REVISION 3 PAGE CHANGES TO THE
SPENT FUEL POOL RERACKING LICENSING REPORT

SAN ONOFRE NUCLEAR GENERATING STATION

UNITS 2 AND 3

Revision 3 Replacement Pages

SAN ONOFRE NUCLEAR GENERATING STATION Units 2 & 3
PROPOSED UNIT 2 SPENT FUEL POOL COOLING PIPING SHEET 1 OF 2
FIGURE 3.2-2

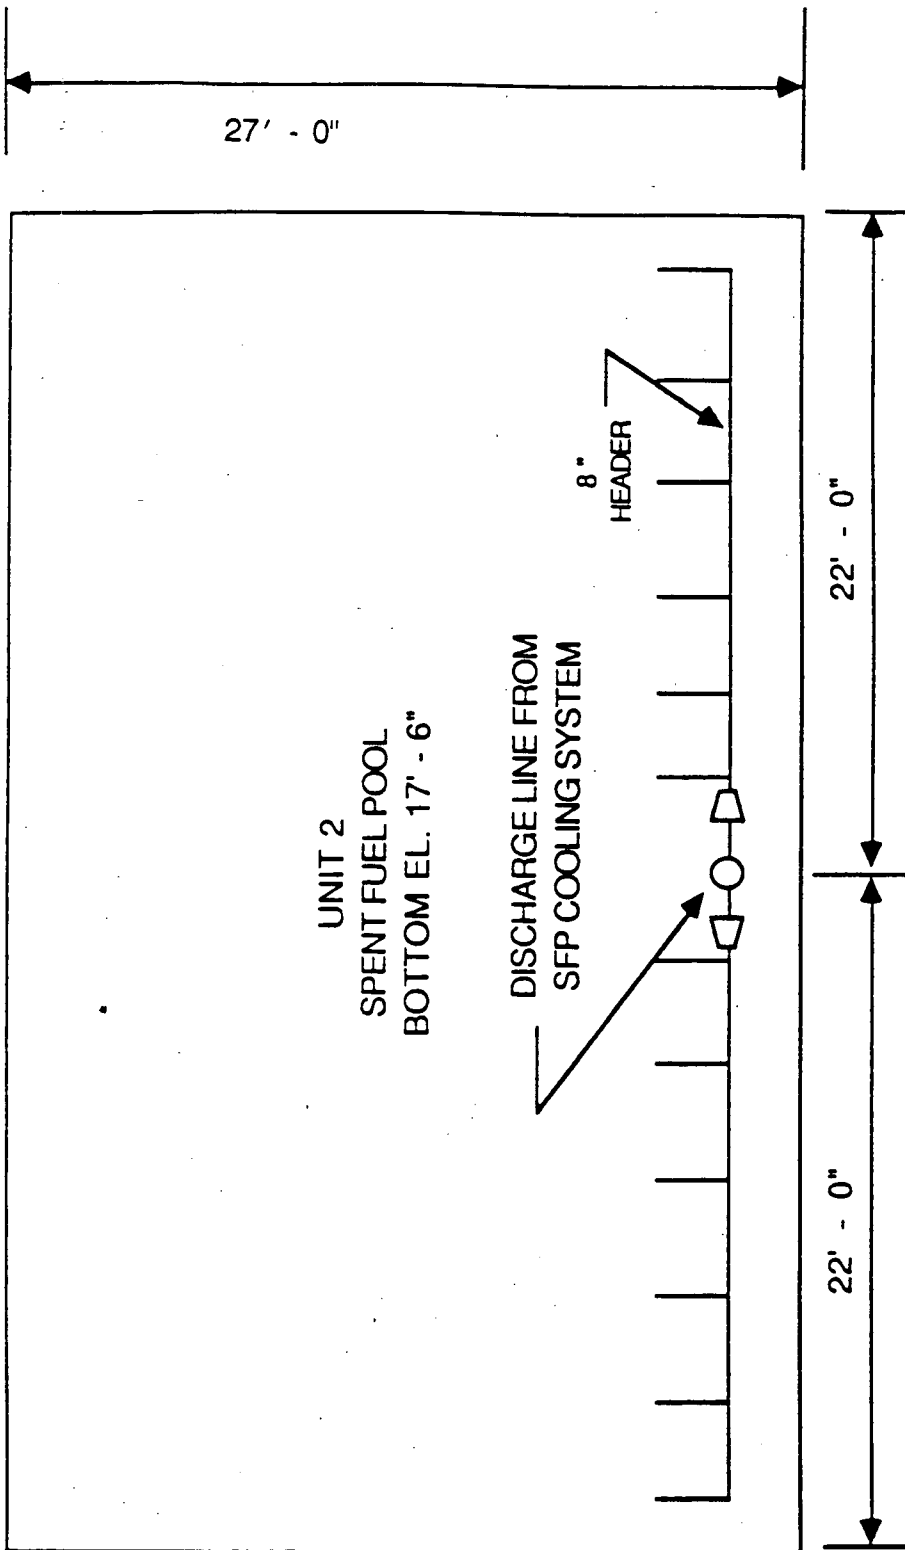
3. Page 3.2-3 Paragraph corrected to indicate that inadvertent pool draining, including siphoning is limited to Technical Specification level.
4. Figure 3.2-2 Corrected spent fuel pool width at bottom from 23 feet to 27 feet. (There is a 4 foot overhang on the west side at the top of the pool.)
